Comment A – Some hydrologic considerations for storage of High-Level nuclear waste at the Holtec Site in Lea County, New Mexico

COMMENT (286)

PUBLICATION DATE: 3/30/2018

CITATION # 83 FR 13802

FIGURE 1 - LOCATION MAP FOR WIPP AND HOLTEC SITES

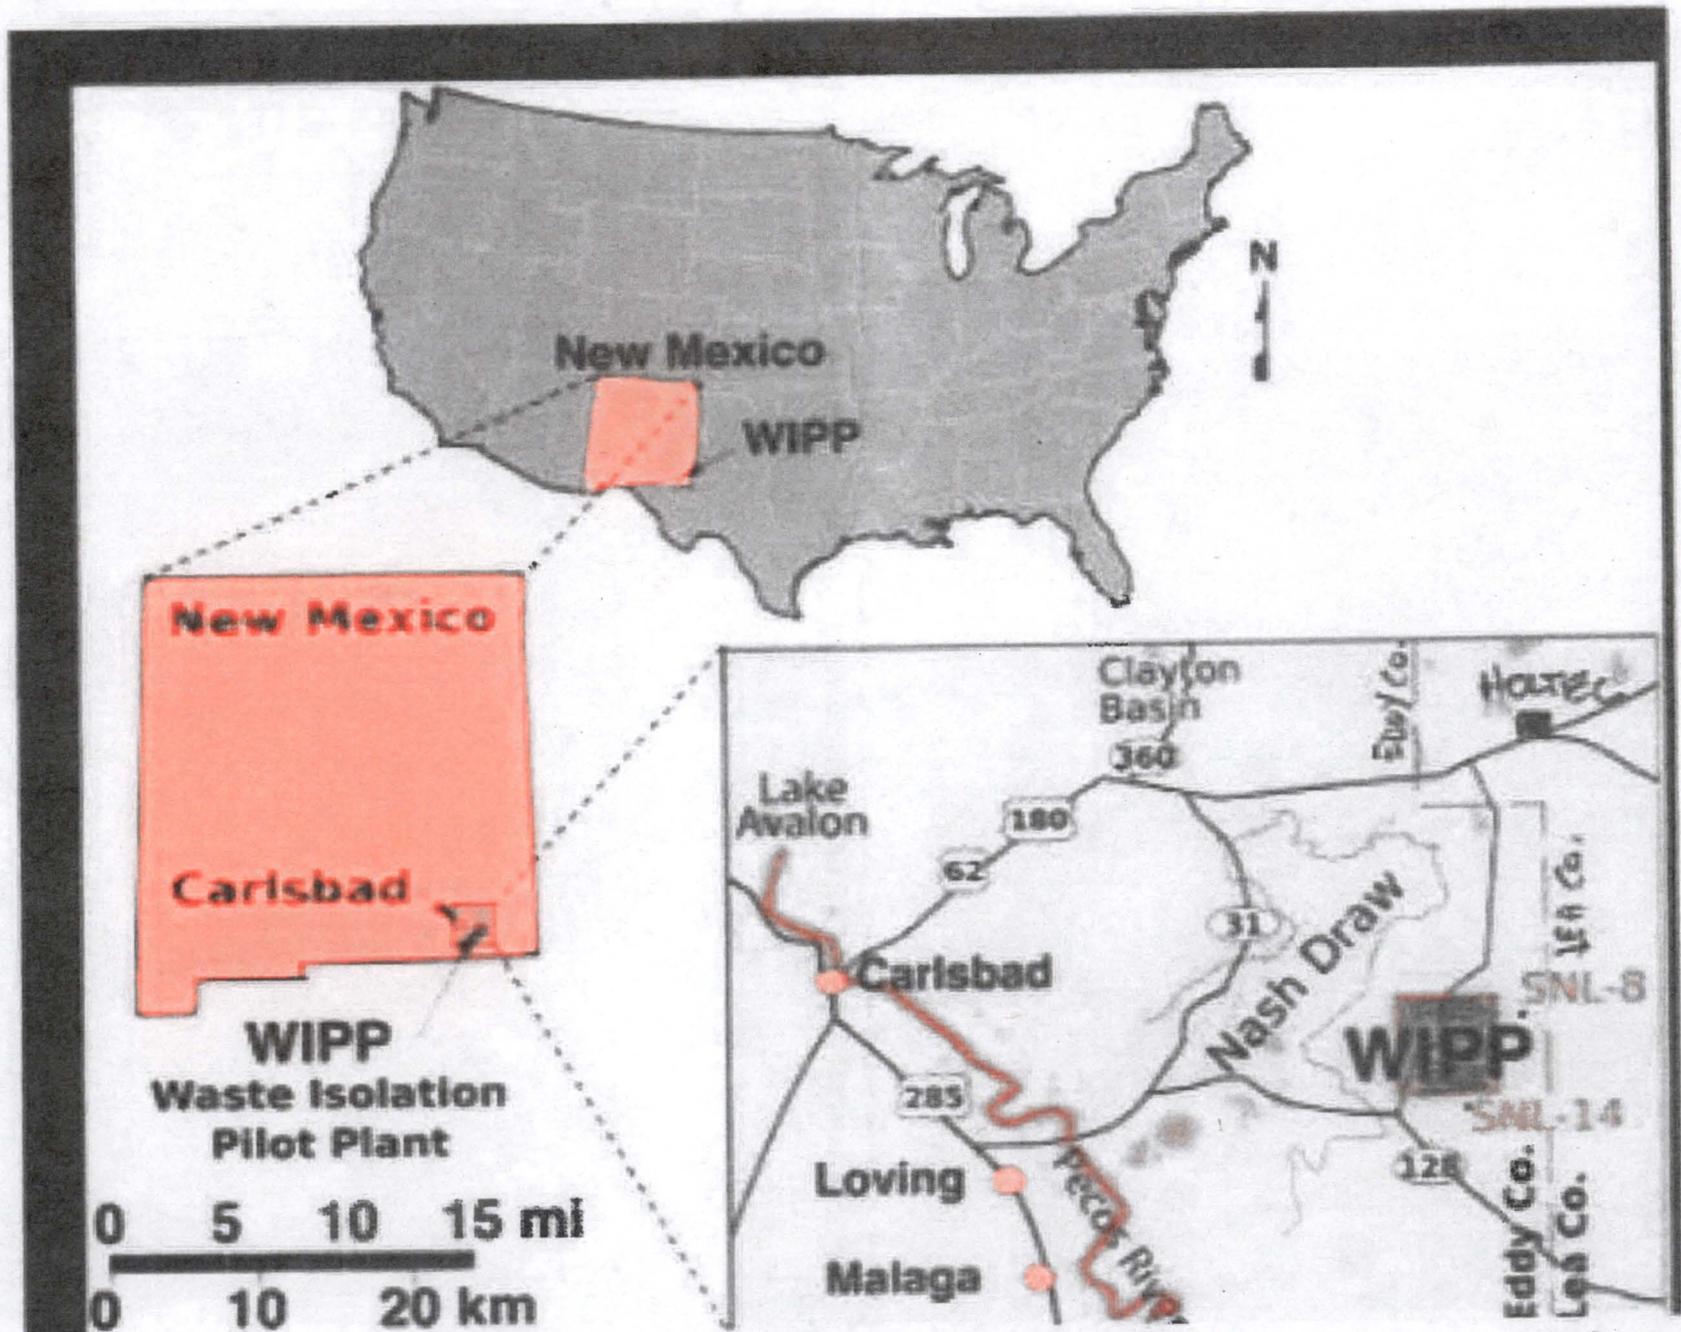
There are significant risks associated with present storage of spent, high-level (H/L) nuclear waste on the premises of the nuclear power-generating facilities that generated it, particularly when they are located in densely populated areas (this risk is significant and a solution is urgently needed): The Holtec plan to use a 1000-acre site in western Lea County, New Mexico as temporary storage for such waste in preparation for removal to a permanent storage site has merit, but neither Holtec nor the Nuclear Regulatory Commission (NRC) has guaranteed that such removal will take place. It seems feasible that after as much as 85,000 tons of H/L waste (estimated total now stored at generating-facility locations (NRC, 2009)) has been moved to this low-population, low-rainfall site and placed in shallow storage crypts, much of the national concern over the present storage problem would abate, and nothing further would be done to move the waste to secure, permanent, safe storage elsewhere (specifically, to WIPP 15 miles to the SSW – Figure 1).

FIGURE 2 - SATELLITE PHOTOGRAPH OF SALINE PLAYA LAKES IN THE VICINITY OF THE HOLTEC SITE

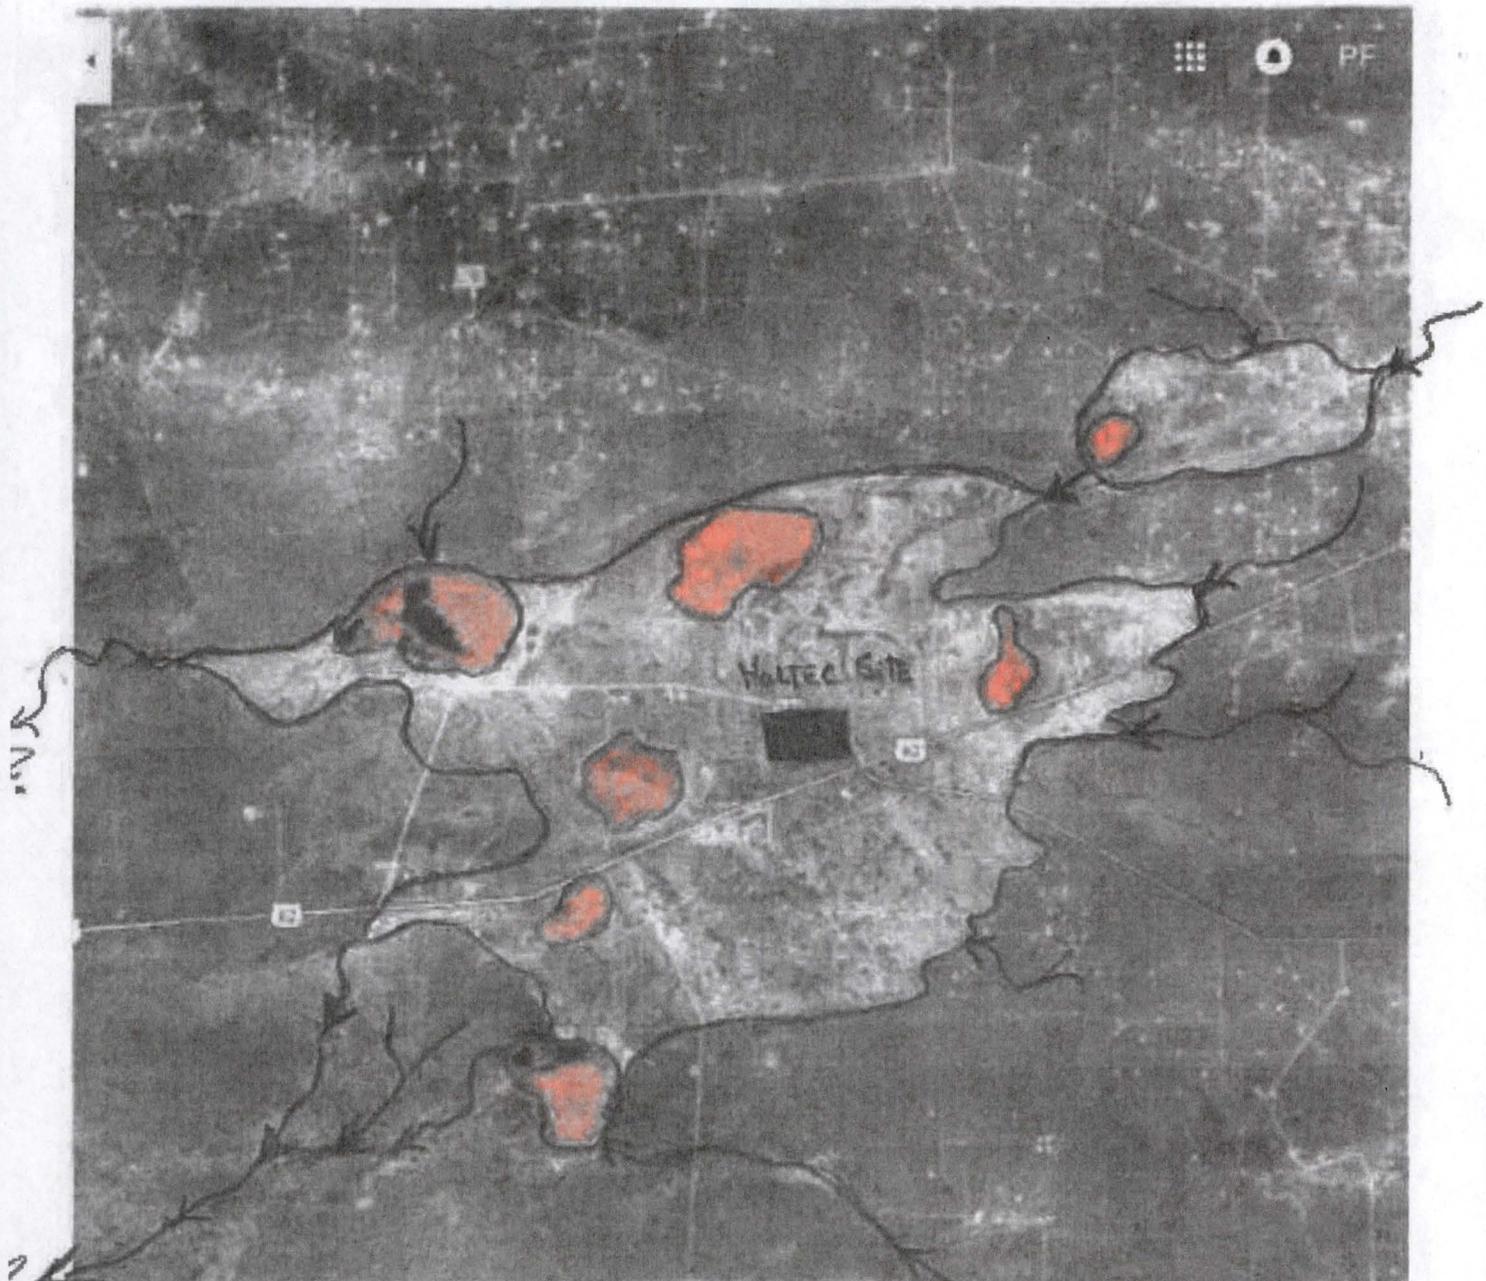
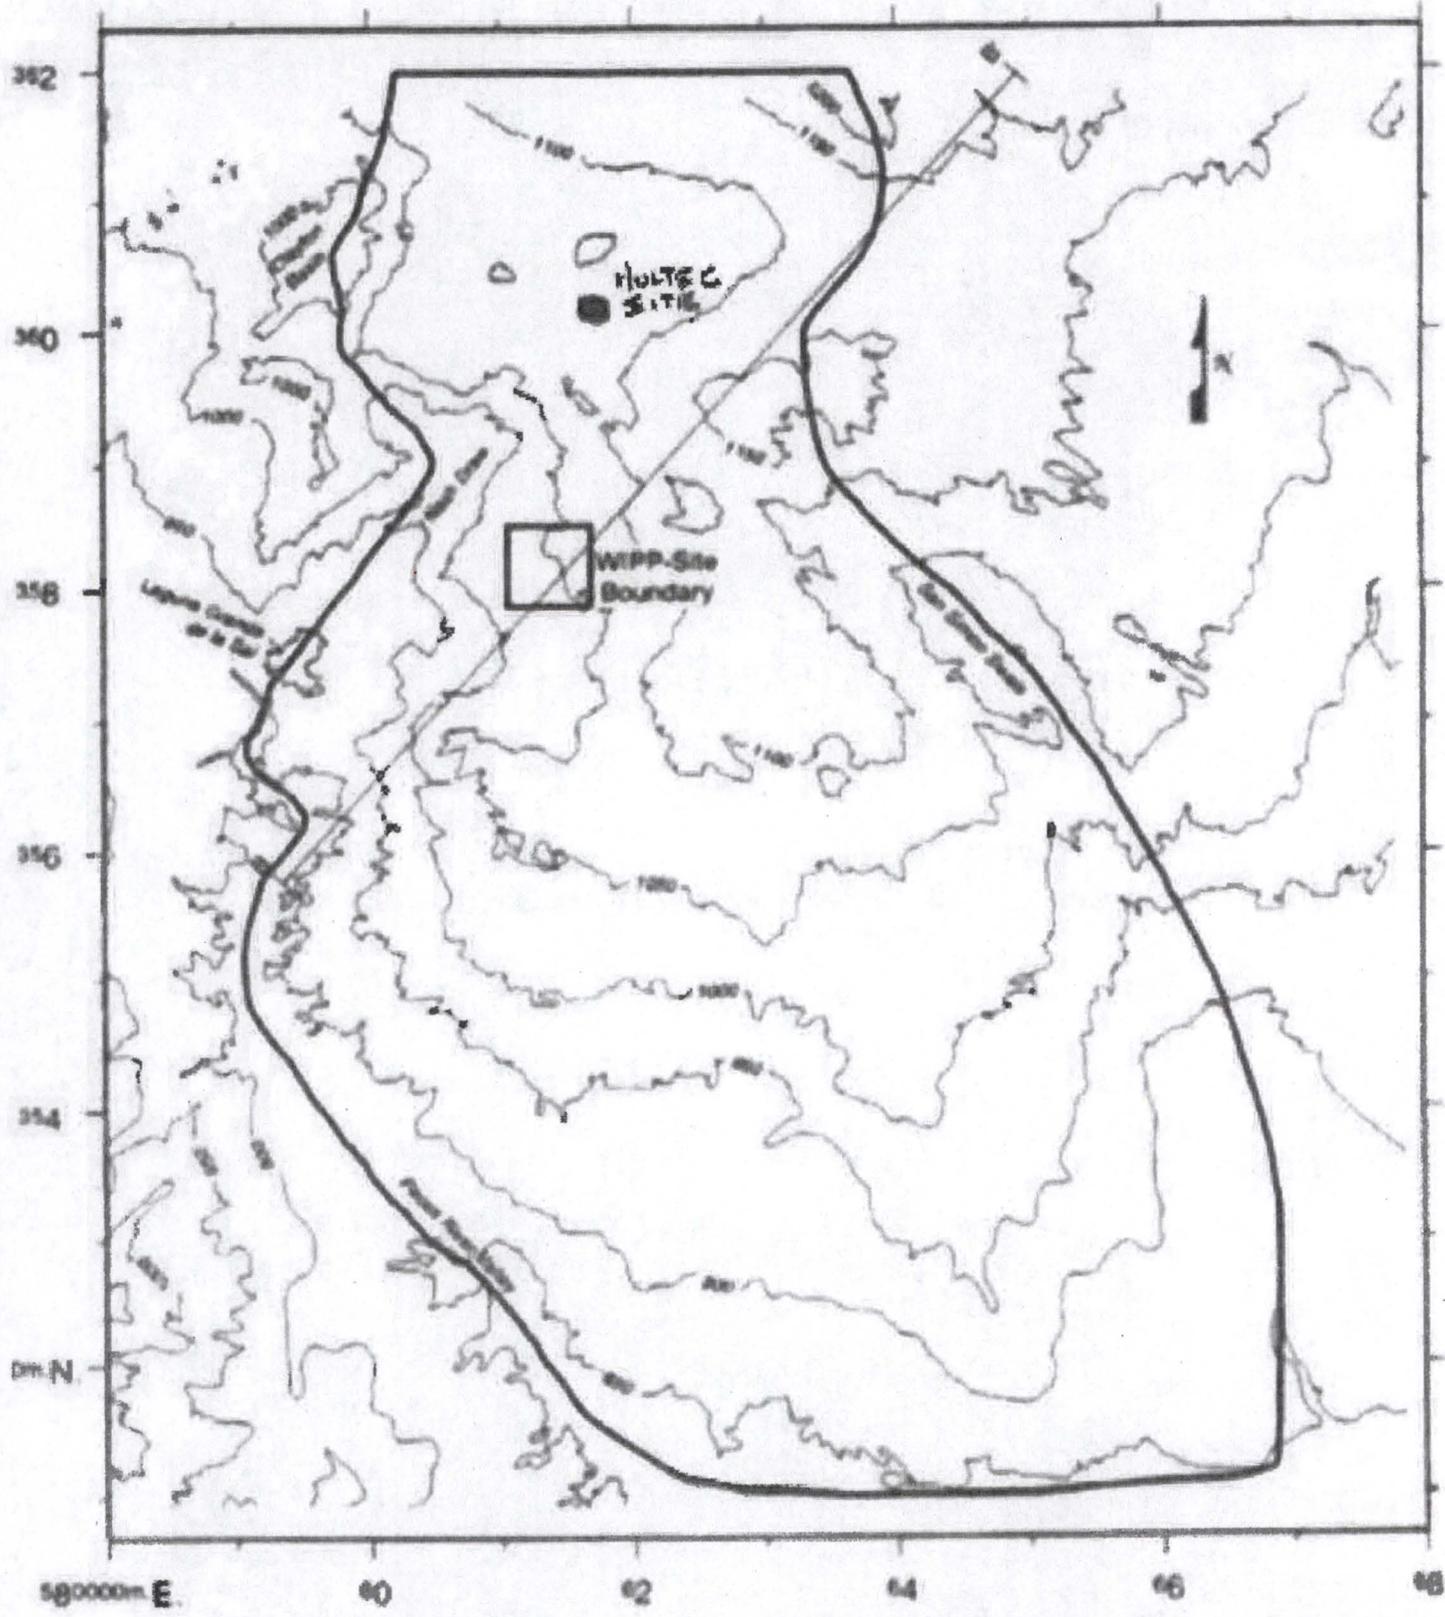
- A) **Isolated aquifer** – **Figure 2** shows the location of 7 playa lakes located near HS. A survey of playas in New Mexico (**Playa Lakes, Joint Venture, 2016**) indicates that these lakes all contain saline water. Satellite photos were used to outline a bleached zone around these lakes comprising a sizable area underlain by unconsolidated sediment where surficial vegetation has been affected (?) by saline waters within a Playa Area, (PA - the PA and its lakes may be associated with deep dissolution of the salt section by upwelling waters from the underlying Capitan Reef aquifer (**Bachman, 1987**)). These same photos were also used to establish the location of surface channels outside the PA along which rain-generated runoff could carry water into the PA allowing downward infiltration to the water table but also causing run off downslope out of this area to the SW into Nash Draw (**Figure 1** - the land surface around HS slopes to the SW - **Figure 3, Corbet, 1996**). It is probable that an isolated water-table aquifer now exists within the PA (Holtec has documented shallow water levels within unconsolidated sediment below HS and they report that depth to water was often less than 15 feet.). Over longer time frames, random rain-generated surface-water inflows into the PA accompanied by infiltration into the underlying aquifer could cause (periodic ?) downslope ground water flow through this aquifer from NE to SW. Such ground water flow could carry contaminants from any cask leakage that travelled down into such sediments out of the PA and into the Accessible Environment (AE) down gradient to the SW, including into lakes within the PA, and into shallow flow in Nash Draw. This potential problem could be rectified by moving the HS away from the PA to nearby bedrock (Triassic fine-grained outcrops with their cation exchange capacities ?), but risks associated with a new location should be fully re-evaluated.

FIGURE 3- MAP OF TOPOGRAPHY IN THE WIPP AREA  
(FROM CORSET, 1996)

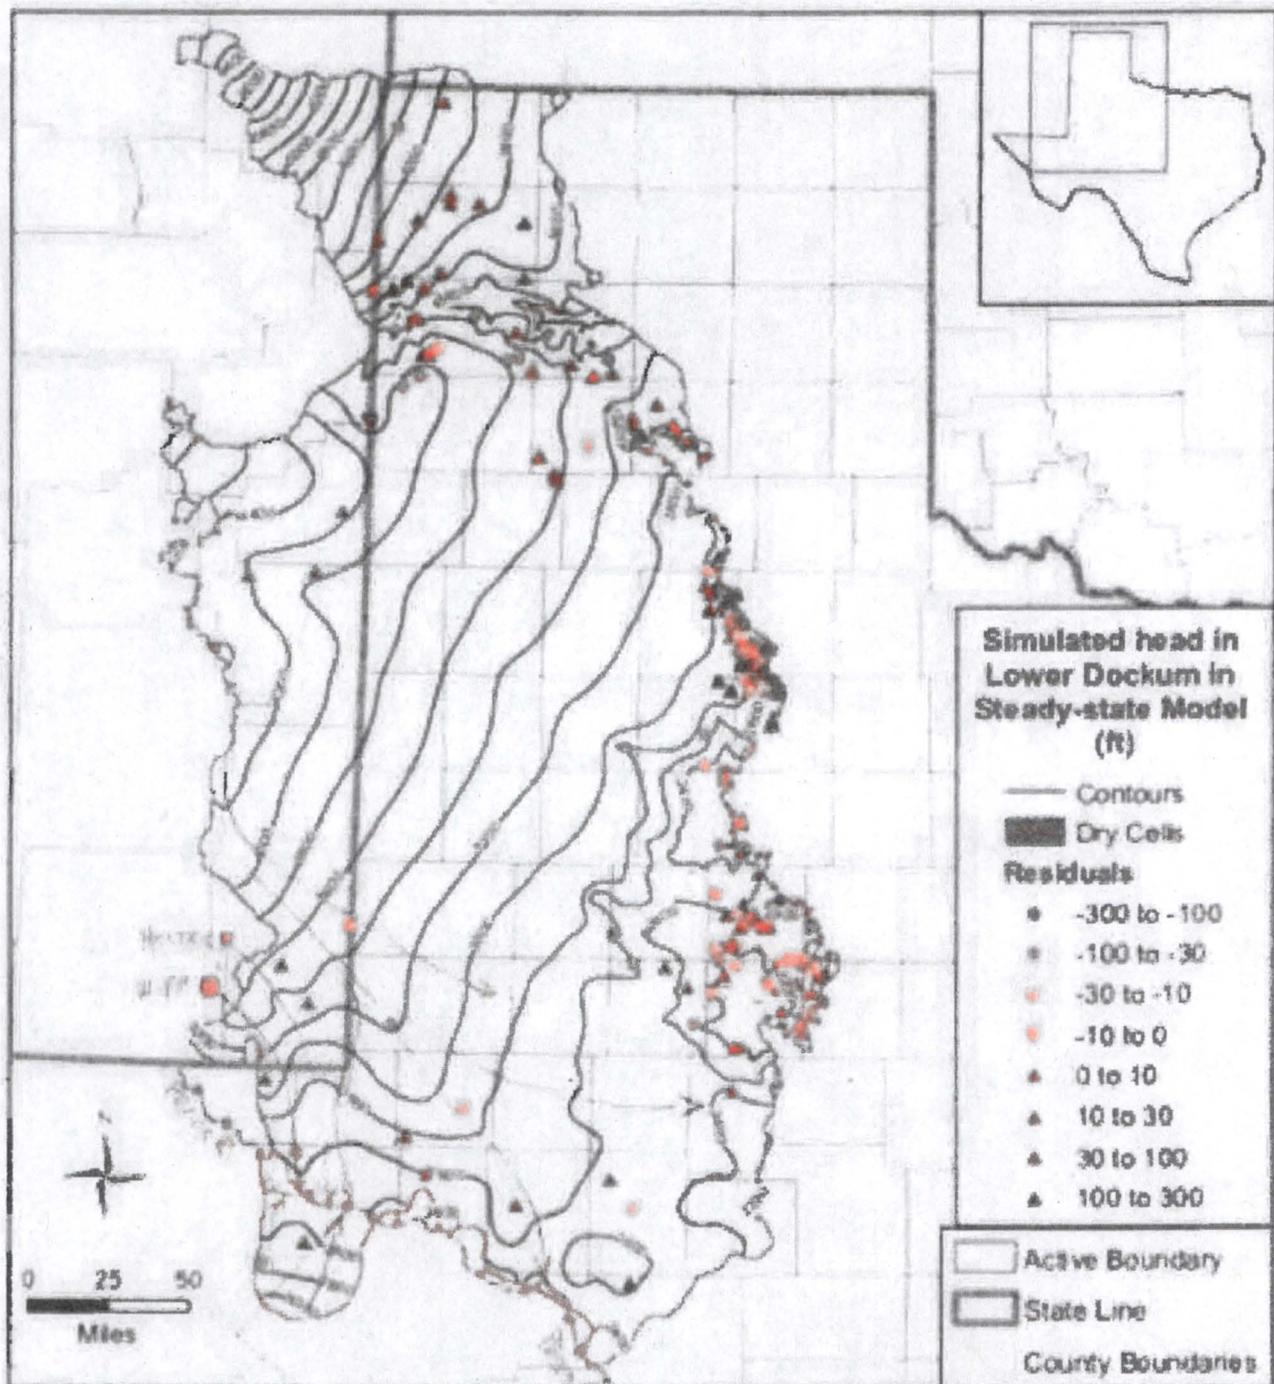
- C) - **Rustler Aquifer** - the Permian Rustler Formation and its aquifers lie beneath the HS (Bachman, 1987, Map of Rustler Fm – Figure 7). Deeper vertical contaminant transport through and below the Triassic within the bounds of HS could reach the Rustler Formation and there, contaminants could be transported southward in ground-water flow within this confined aquifer, and eventually taken into the Pecos River itself (Corbet, 1996, water-level map with flow lines – Figure 8) – and once again, eventually into the Rio Grande.. Hale (1945) suggested that saline waters within the Rustler Aquifer did flow into the Pecos River within New Mexico in the reach between Malaga Bend and the Texas State line (Figure 7). Within their modeled area (Figure 7), Corbet and Knupp (1996) describe the Rustler close to the Pecos River as grading into a permeable collapse breccia through which Rustler aquifer water within the modeled area flows into the Pecos River.
